NAME OF CUSTOMER: NABINAGAR POWER GENERATING CO. PVT. LIMITED (NPGC)
NAME OF PROJECT : 400/132 KV SWITCHYARD PACKAGE AT NABINAGAR SUPER THERMAL POWER PROJECT (3 X 660 MW)

400KV NABINAGAR TPP (BRBCL) EXTN – SINGLE LINE DIAGRAM

NTPC DRAWING NO. 0370-572-PVE-F-442				
CUSTOMER NABINAGAR POWER GENERATING CO. PVT. LTD. (NPGC)				
PROJECT : NABINAGR STPP (3X660 MW) 400/132kV SWITCHYARD PACKAGE				
CONTRACTOR 	BHARAT HEAVY ELECTRICALS LTD. TRANSMISSION PROJECTS DIVISION NEW DELHI	DEPT CODE DRN CHD APPD	NAME RK SK DKM/RS	SIGN
TITLE Equipment Earthing Philosophy & Details				
DEPT.	SCALE	DRAWING NO. TB-4-350-316-017		
SIGN		SHEET 01 OF 22		
DATE		REV. 00

EQUIPMENT EARTHING DETAILS NOTES

SECTION A-A

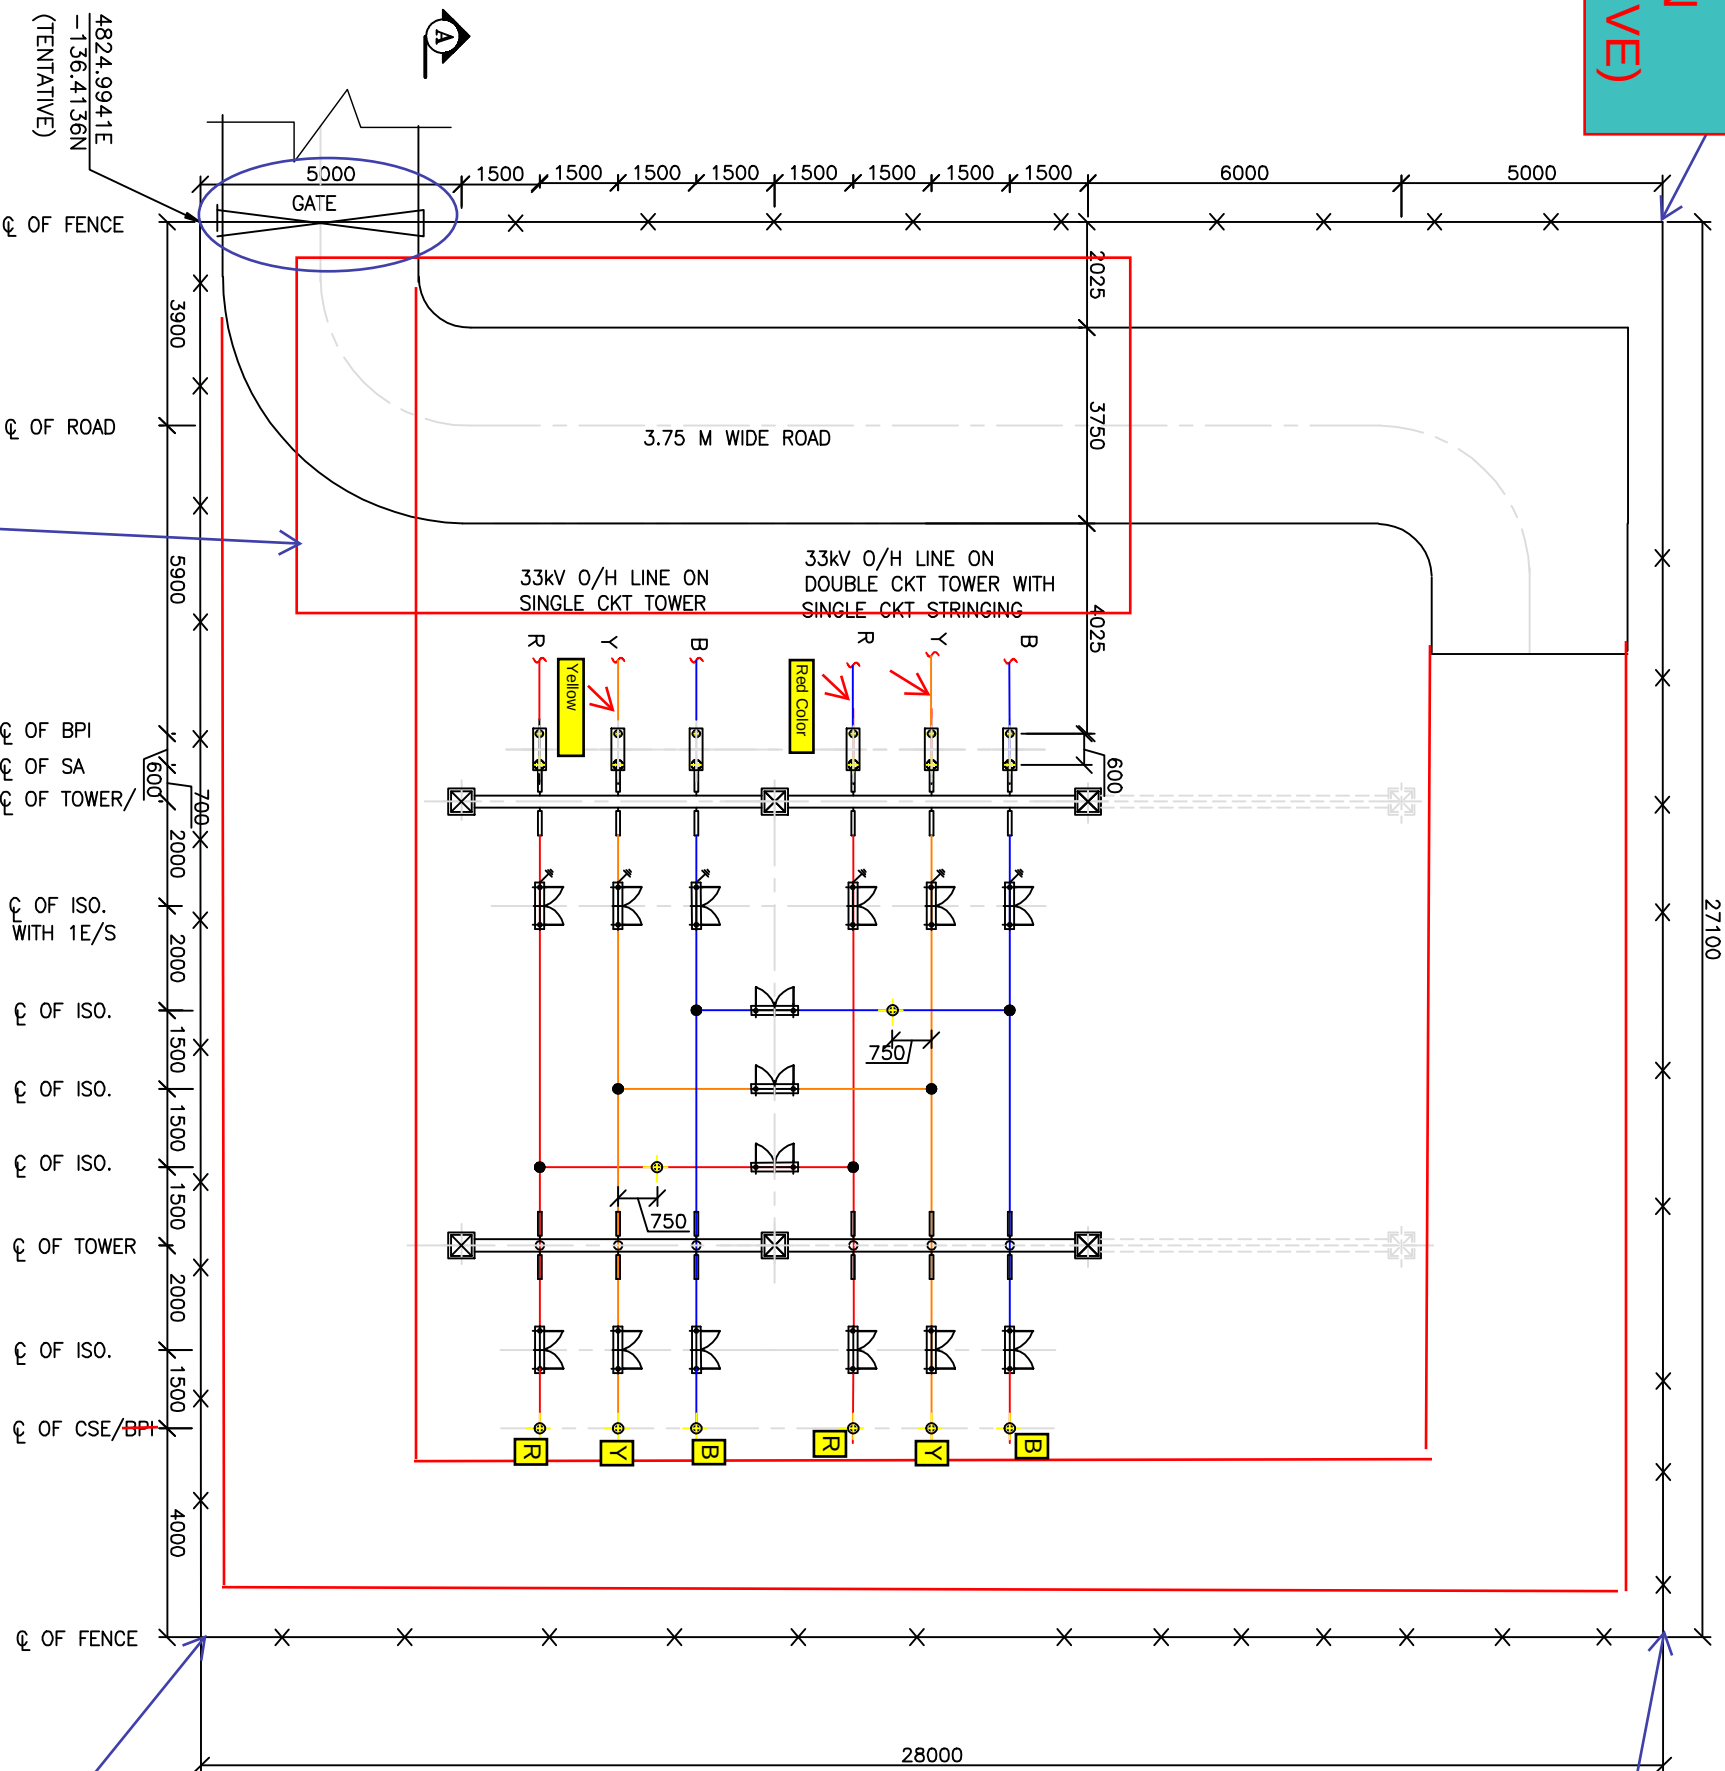
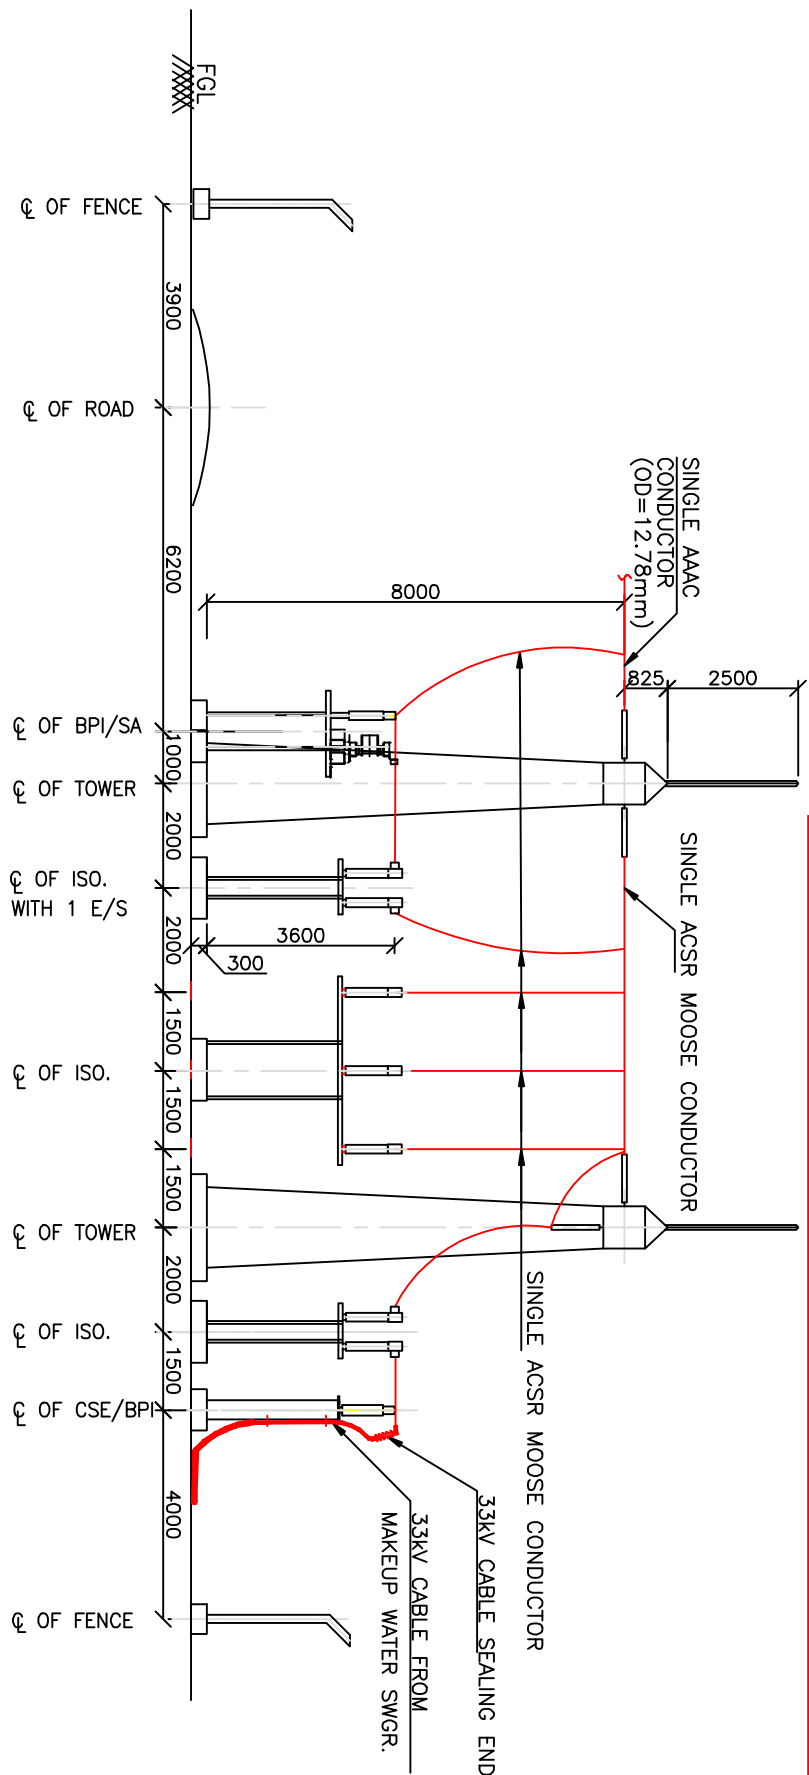
Please provide the suitable road and accordingly revise the dimensions considering adequate clearances.

Please ensure and show the provision for lighting and lightning protection.
Distance between equipments/ other facilities and equipments requirements are subject to meeting clearances.

PLEASE CHECK FOR ELECTRICAL CLEARANCE.

REVISE AS PER THE COMMENTS MARKED ON THE 400 KV STRUCTURAL LAYOUT.

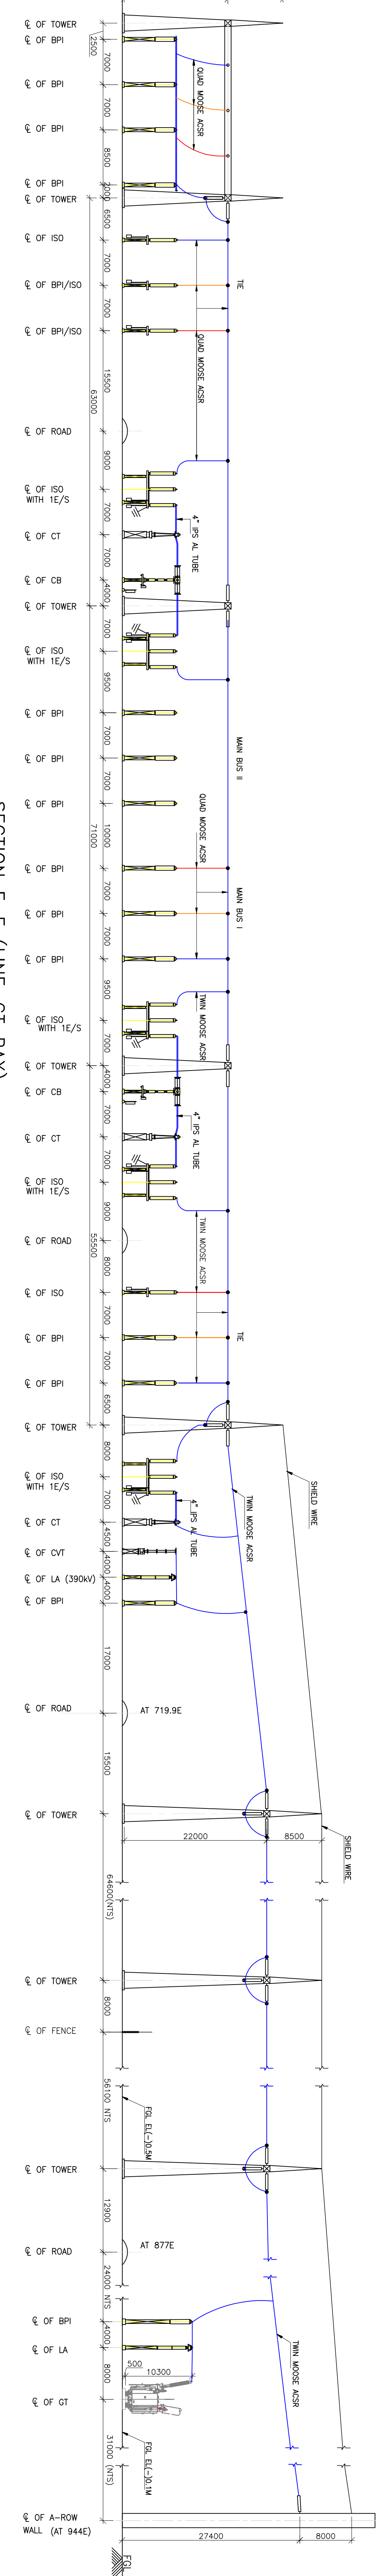
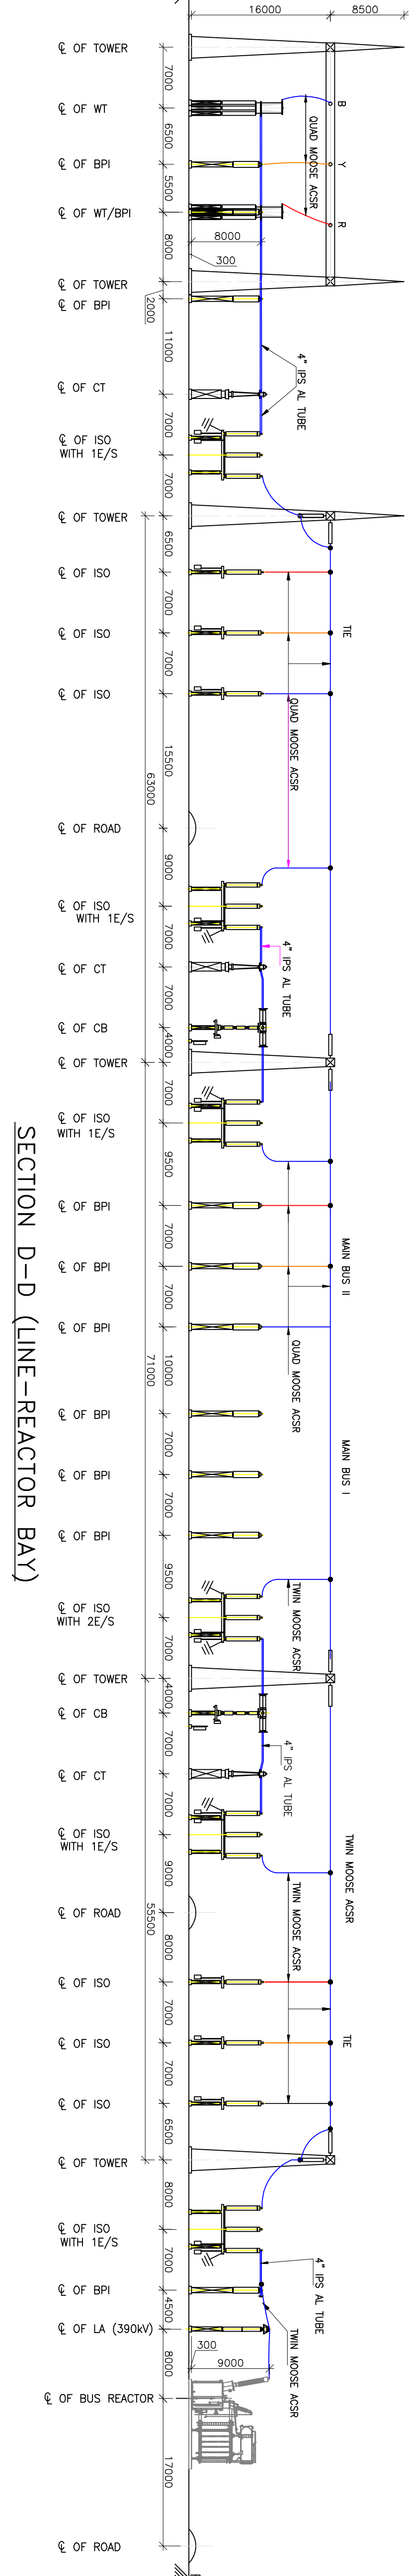
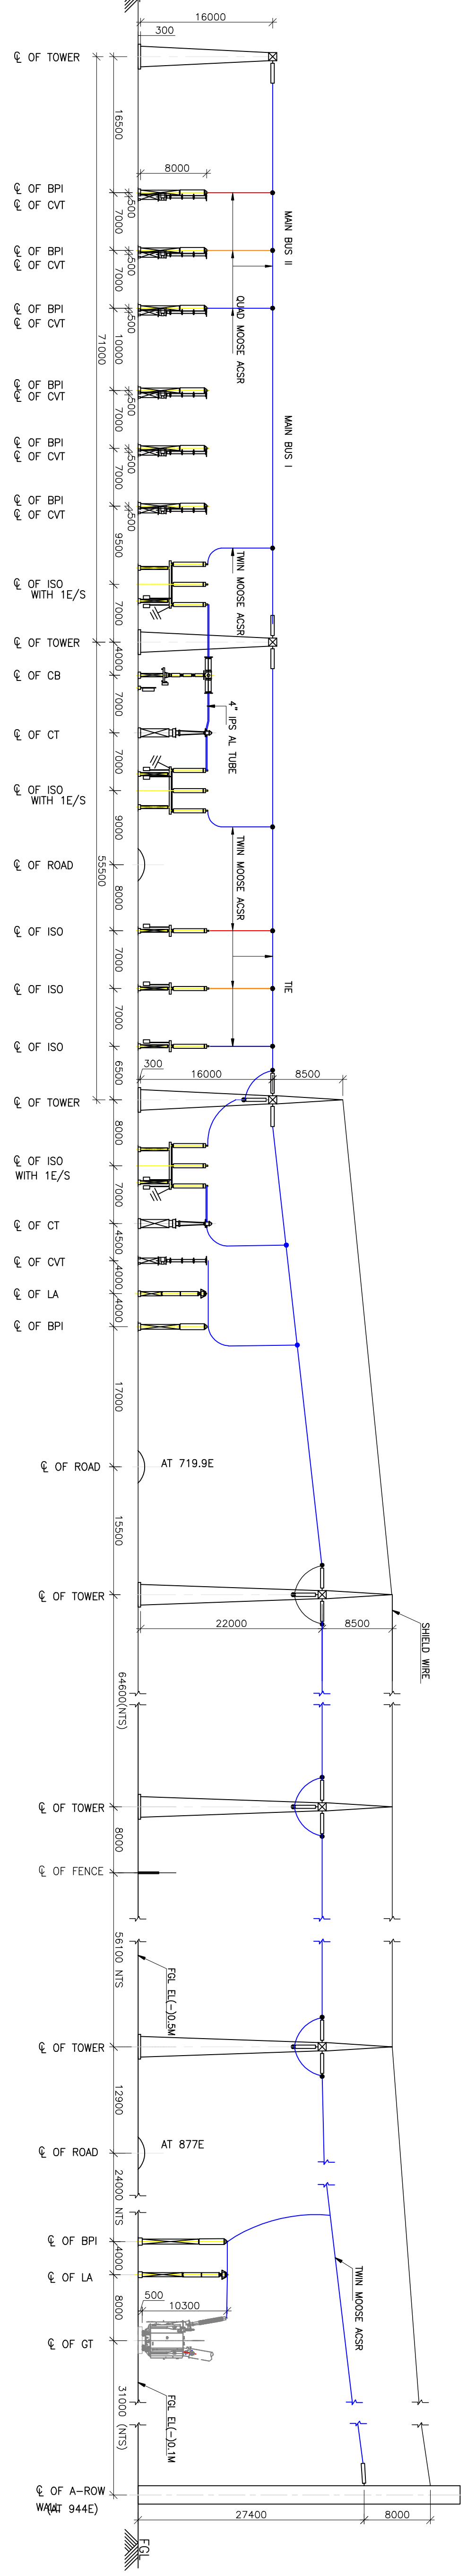
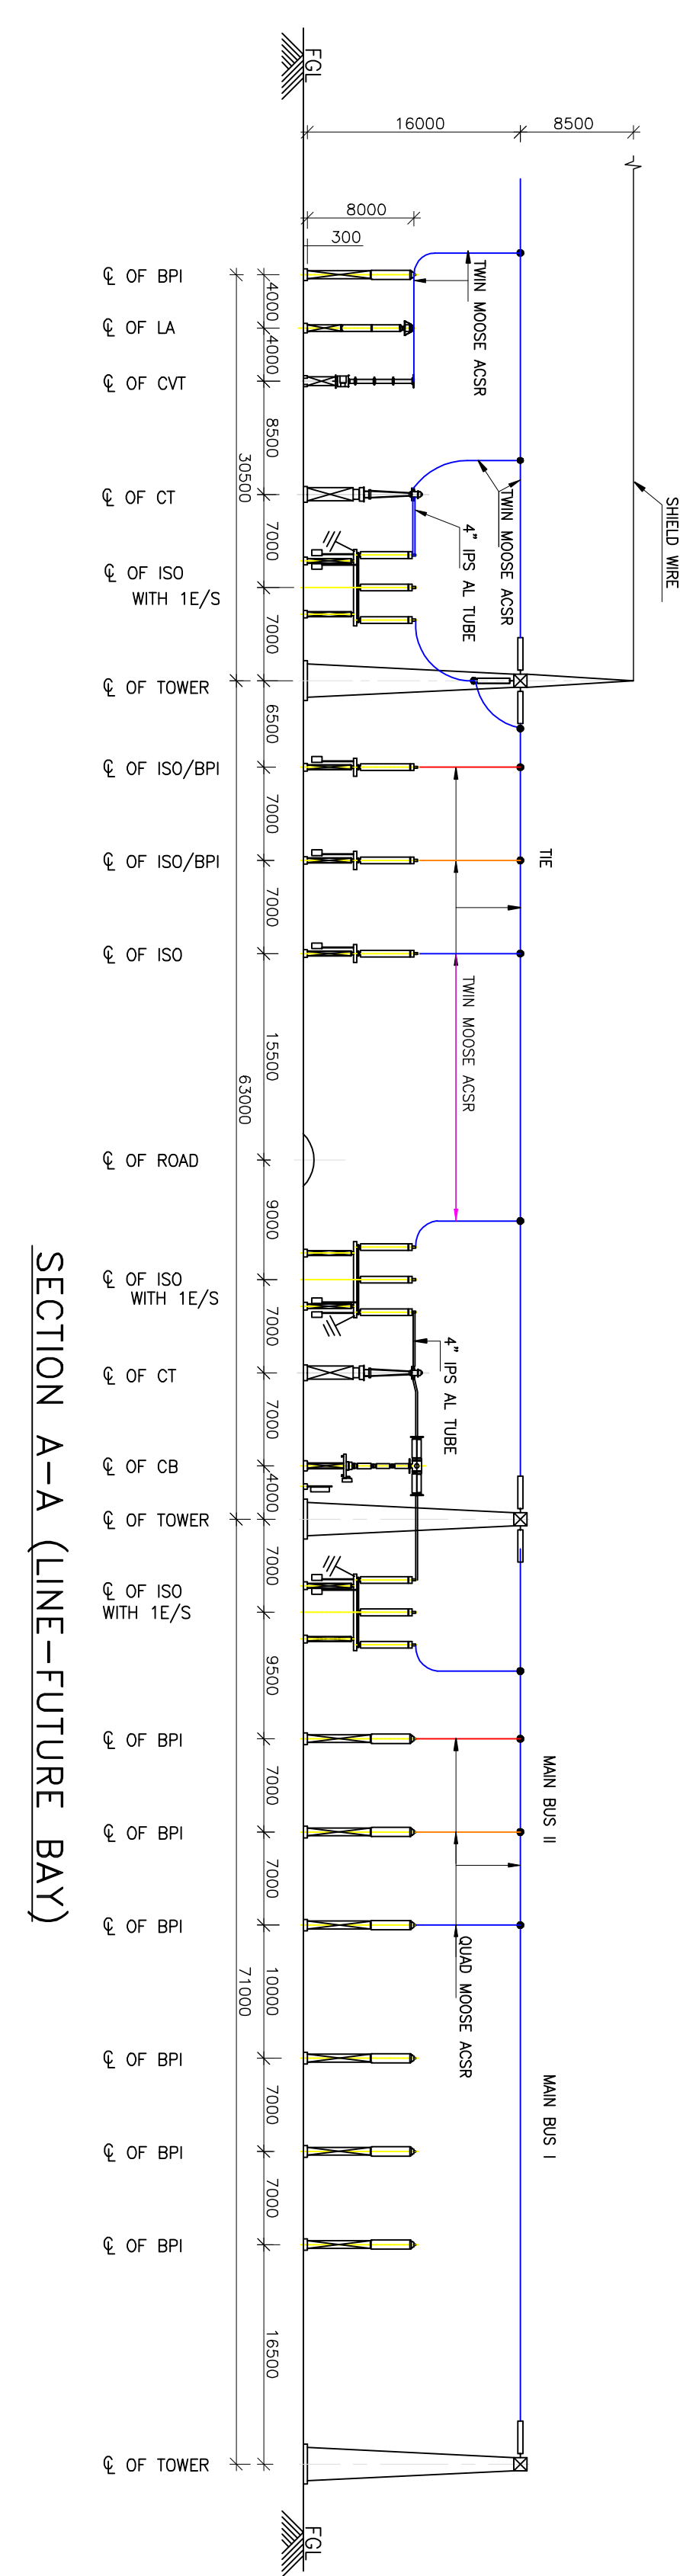
1. Distance between the equipments/ other facilities are subject to meeting clearances.
2. Please show the R, Y & B phases in their respective colors i.e. Red, Yellow and Blue color for all the phases.
3. Quantity & location of LVA are subject to DSI-P calculations
4. Nos of AC Kiosk shall be as per spec requirements.

MARK TOWER AND GIRDER NOMENCLATURES IN SUBSEQUENT REVISIONS.

YOU ARE REQUESTED TO INCLUDE THE LAYOUT AT MAKE-UP WATER END AS WELL IN SHEET 2 OF THIS DRAWING.
